Question 17: the library over the Great Hall

The Architect, 14 October 2026, for Godric. Ledger line 13 (req 328, Interiors' schedule); the castle model, version 20, and the layout PDF. All at 1:500: plans north up, sections cut through a bay at x 49.5, looking west. Red: what changes.

1 Floor 4: two storeys, north-lit

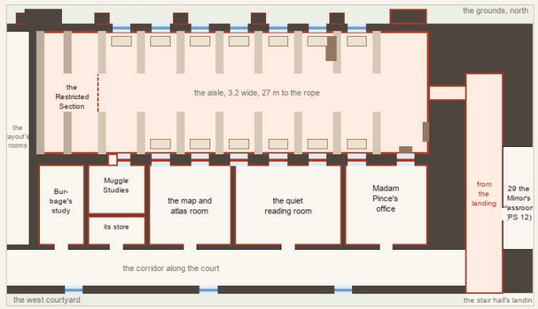
1, recommended. Two storeys, floors 4 and 5, 9.7 clear (Interiors asks at least 4.8 over presses 3.0 high), a window in every north bay, 1.4 by 7.0 from a sill 1.0 up, to the grounds (Ron's "library window", PS 14). Daylight from a head 8.0 up reaches about twice that, so it crosses the 10 m to the south tables over the presses; they keep their places, unwindowed. Floor 5 over the library gives up the layout's w, s and o; nothing above floor 5 and no roof moves.

3 Floor 4: one storey

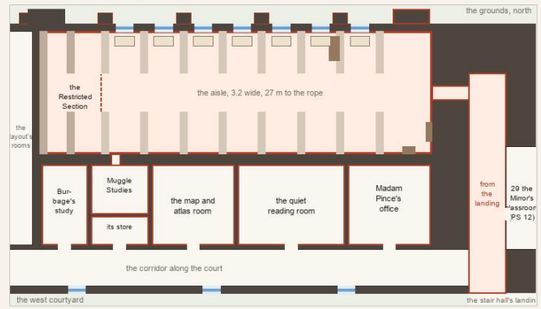
3. One storey on floor 4, 4.5 clear, under Interiors' 4.8; north windows 1.4 by 2.8; the south tables kept with lamps; floors 5 to 7 as the layout holds them.

2 Floor 5: a light court over the band

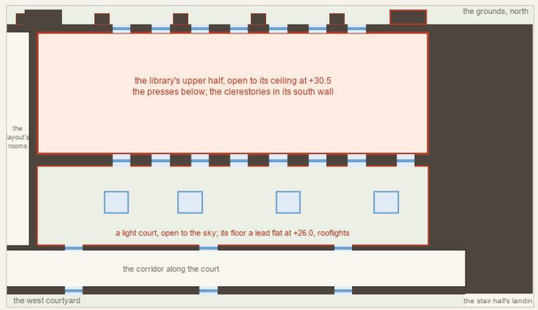
2. As 1, and a clerestory in every south bay, as Interiors' schedule asks: the band's roof at floor 5 becomes the floor of a light court 6.5 by 32 open to the sky, so floors 5, 6 and 7 over the band give up their rooms and the hall's gable splits into two roofs either side of it. From a clerestory the sky shows only above 64 degrees, at the foot of a court 15 m deep.
